HISTORIC AND DESIGN REVIEW COMMISSION

HDRC CASE NO: 2026-196
ADDRESS: 427 S PRESA ST
LEGAL DESCRIPTION: NCB 904 LOT 41
ZONING: D, H, RIO-3
CITY COUNCIL DIST.: 1
DISTRICT: La Villita Historic District
APPLICANT: Timothy Proctor/Laney Development Group
OWNER: Timothy Proctor/Laney Development Group
TYPE OF WORK: Amendment to a previously approved design regarding materials, facade arrangement, and an increase in height
APPLICATION RECEIVED: July 16, 2026
60-DAY REVIEW: September 14, 2026
CASE MANAGER: Edward Hall

DURANGO APARTMENTS

HDRC Presentation

ELEVATION - WEST
SCALE: 1/8" = 1'-0"

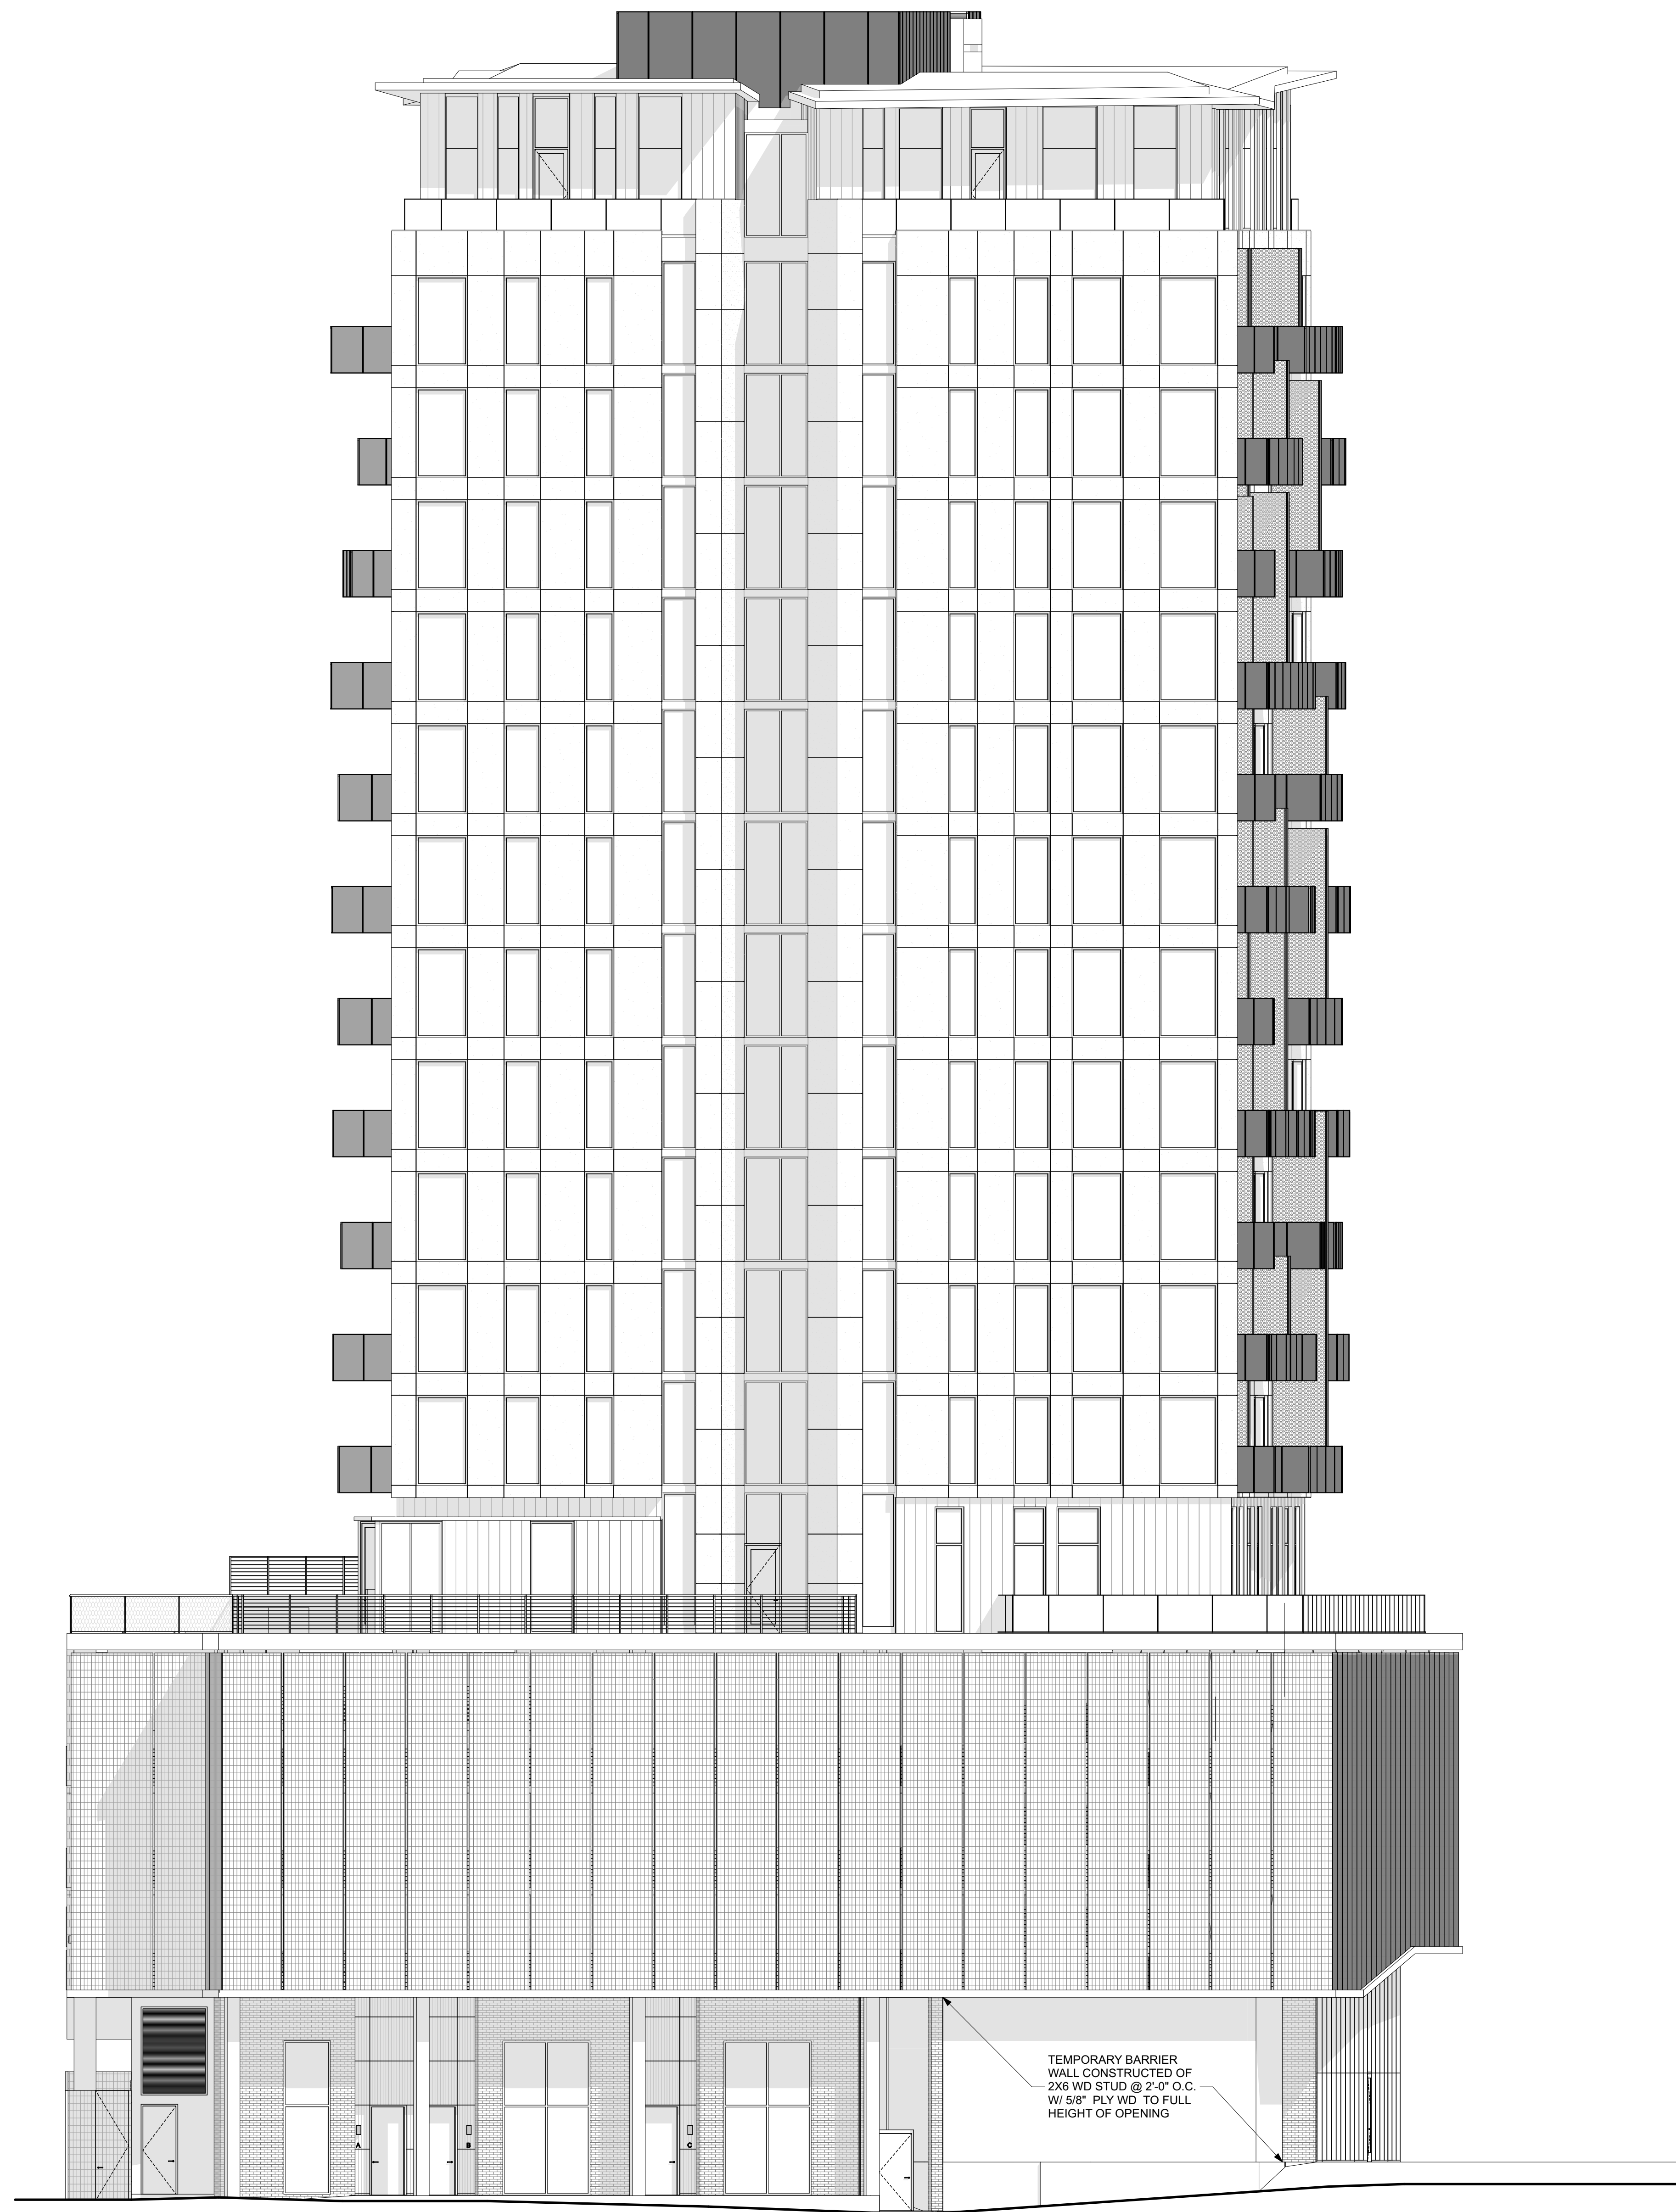
- e. FAÇADE MATERIALS – The applicant has proposed to install white modular brick at the street level on the east, west and south facades. A modular masonry material was previously approved in these locations. Staff finds the new material to be appropriate and consistent with the UDC.

- f. FAÇADE ARRANGEMENT – The applicant has proposed to modify the previously approved façade arrangement by increasing the overall size of fenestration on each façade. Staff finds the proposed amended façade arrangement and fenestration size to be appropriate and consistent with the UDC.

BUILDING EXTERIOR MATERIAL PALETTE

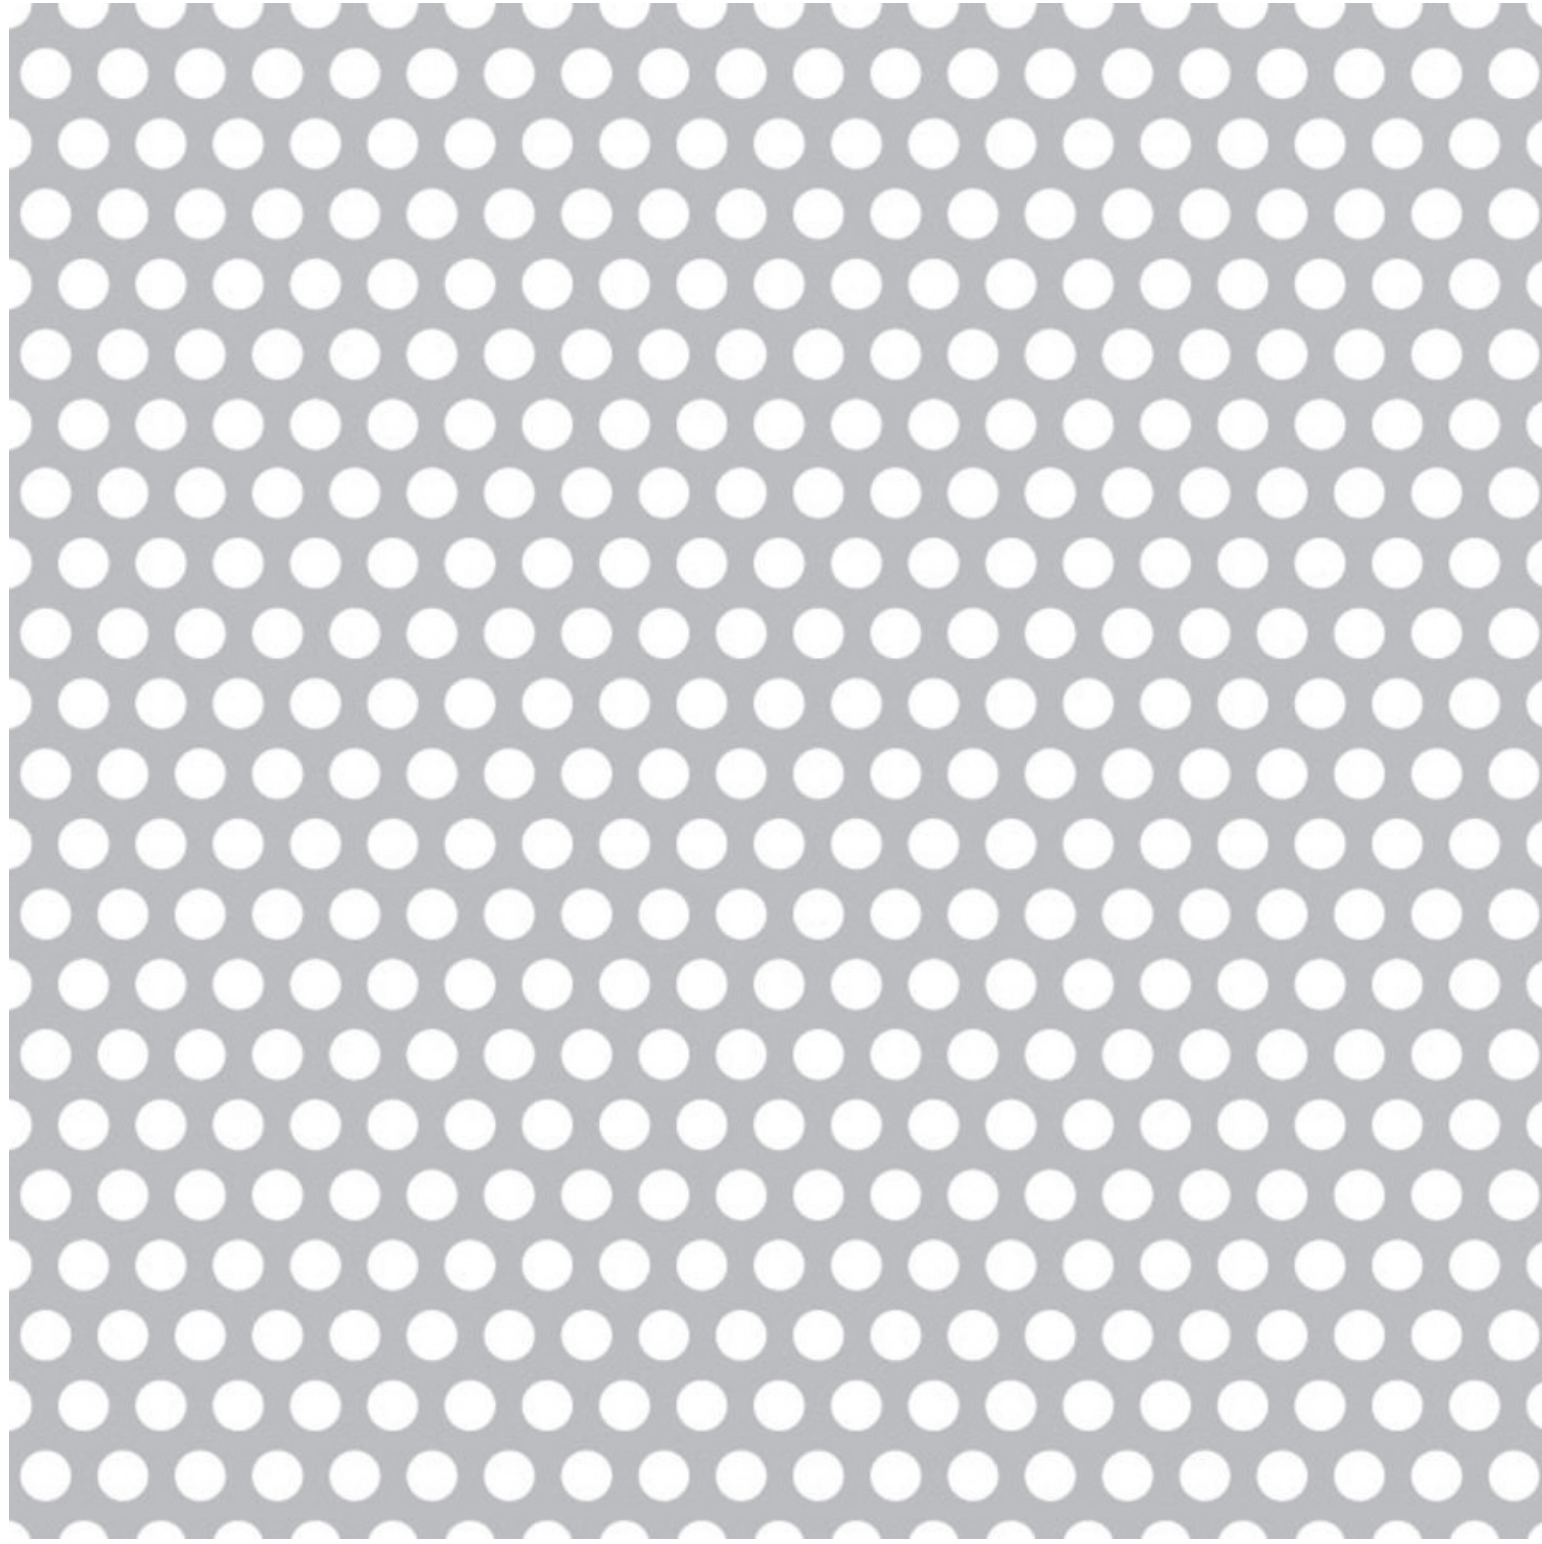
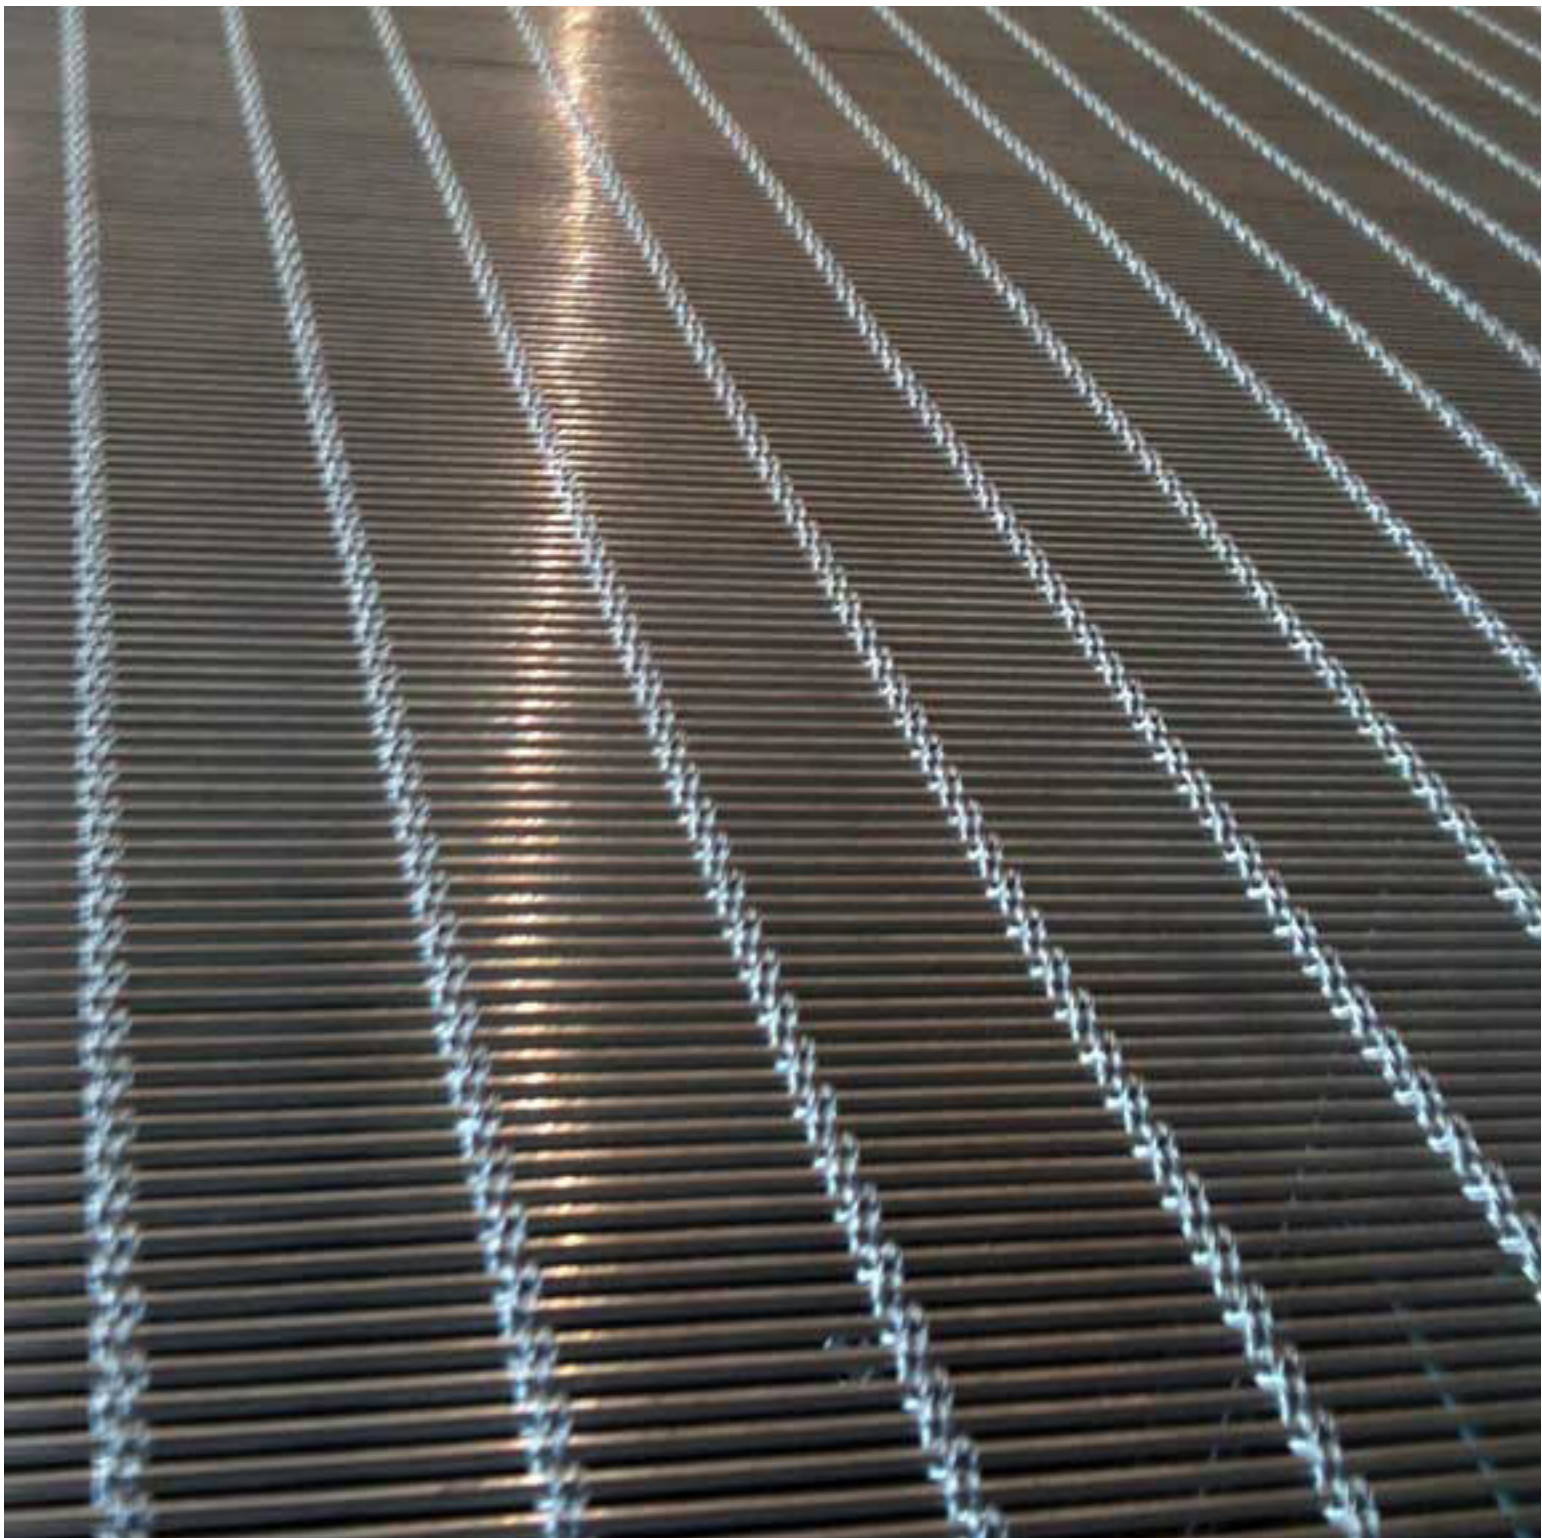
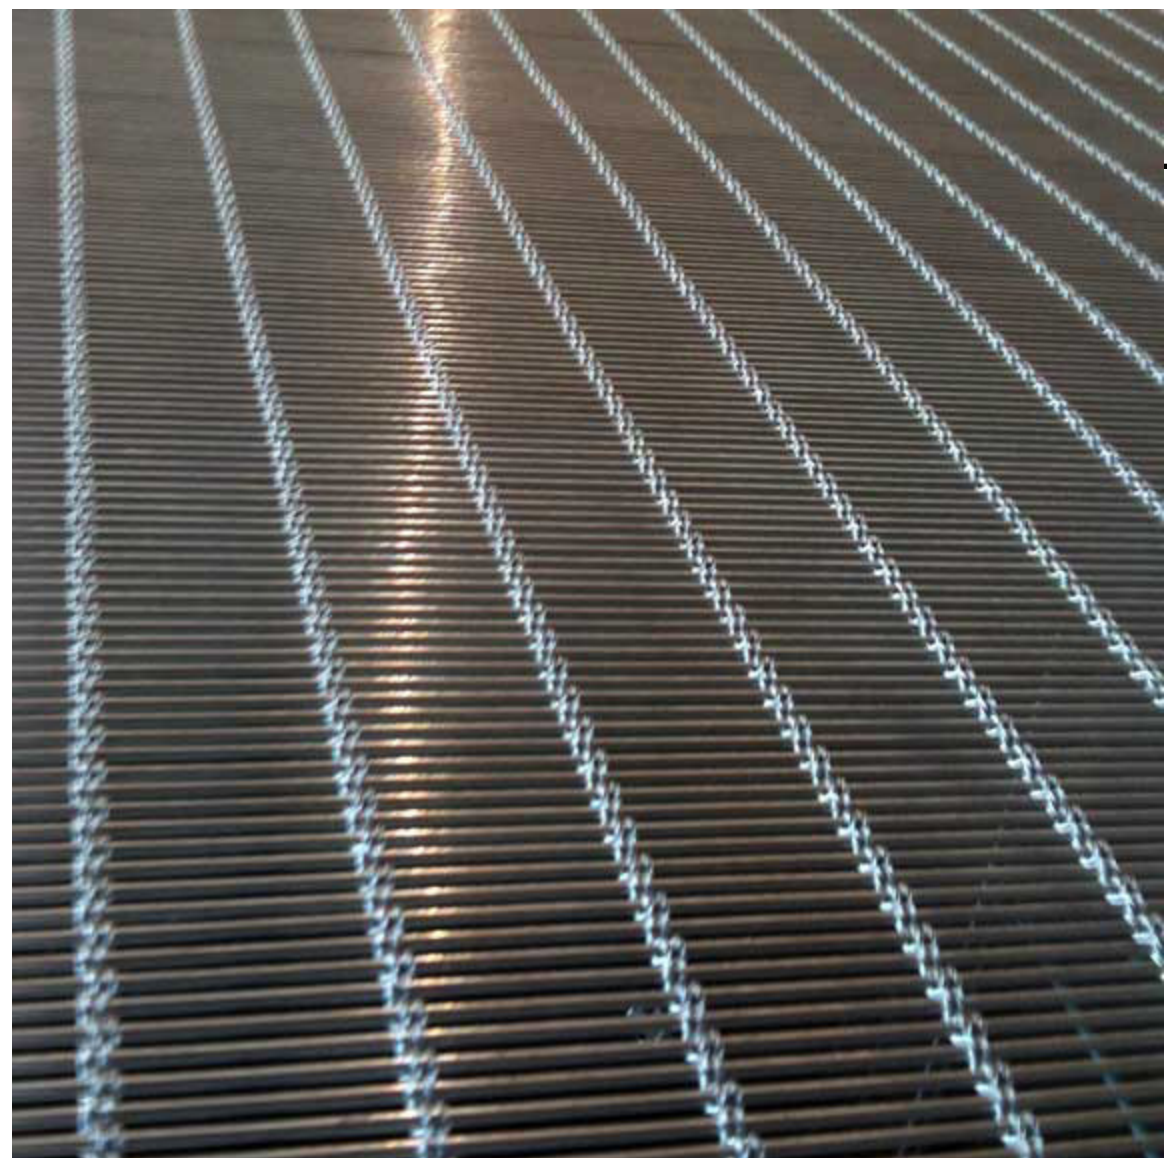
- g. PREVIOUSLY APPROVED ELEMENTS – The Commission previously approved both a rear, painted concrete masonry unit wall (facing north, at the property line), and woven stainless steel screening at the parking levels. Generally, staff continues to find these elements to be appropriate; the concrete masonry unit wall should feature a treatment to mask the appearance of a plain, block wall. Treatments could include a traditional stucco coating, selection of specialized units to create texture or patterns, or a specialized installation method to create texture or pattern. Staff finds that the perforated metal screening be revised to incorporate vertical articulation, alternating colors, and/or changes in plane to create visual interest. Folded panels may also be a solution. Vegetation should be selected for hardiness and longevity; final plant species and maintenance strategy must be submitted to staff. Additionally, staff finds that the balcony railings be revised to include a simple, traditional railing detail in lieu of perforated metal. The applicant may present treatments or specifications for perforated metal to the HDRC for consideration.

- ii. That the parking level perforated metal screening be revised to incorporate vertical articulation, alternating colors, and/or changes in plane to create visual interest. Folded panels may also be a solution. Vegetation should be selected for hardiness and longevity; final plant species and maintenance strategy must be submitted to staff.

- iii. That balcony railings be revised to include a simple, traditional railing detail in lieu of perforated metal. The applicant may present treatments or specifications for perforated metal to the HDRC for consideration.
